BRIEFING DETAILS

PPSSWC-372 – Fairfield – DA 294.1/2023 – 17 Lupin Avenue, Fairfield East - Demolition of existing structures, tree removal and construction of a residential flat building containing thirty-nine (39) affordable housing dwellings over basement car parking containing 40 parking spaces and associated landscaping in accordance with State Environmental Planning Policy (Housing) 2021.

KEY ISSUES DISCUSSED

Figure 1 - first floor

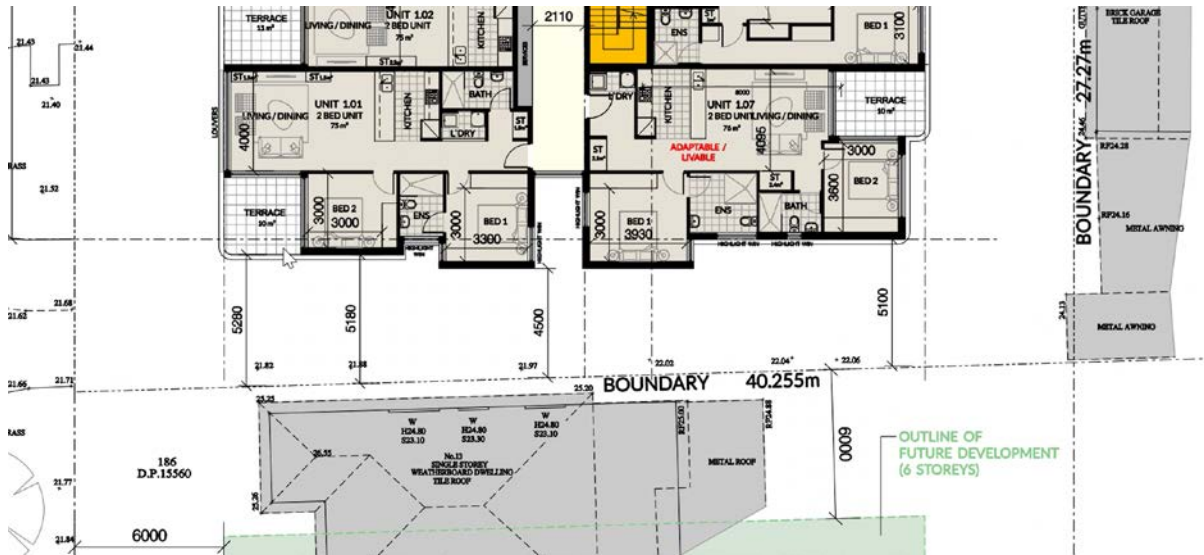
The appropriate application of cl 7.4.3 of the DCP to regulate setbacks from streets was also discussed. Under that clause the 6m front setback area of a Residential Flat Building development to a frontage is not to be used for any purpose other than landscaping. Development is permitted to within 3 metres of any secondary street frontage for no more than 25% of the secondary street frontage only.

Those numerical and pictorial controls are not strictly met by the proposal. These images show the relevant details:

Council has suggested that one way to ameliorate the non-compliances with the encouraged setbacks and associated privacy issues would be to relocate the basement driveway under the building to open up the adjacent setback for landscaping and tree planting.

The Applicant indicated that it was willing to consider that change, and the Panel encouraged discussions to that end.
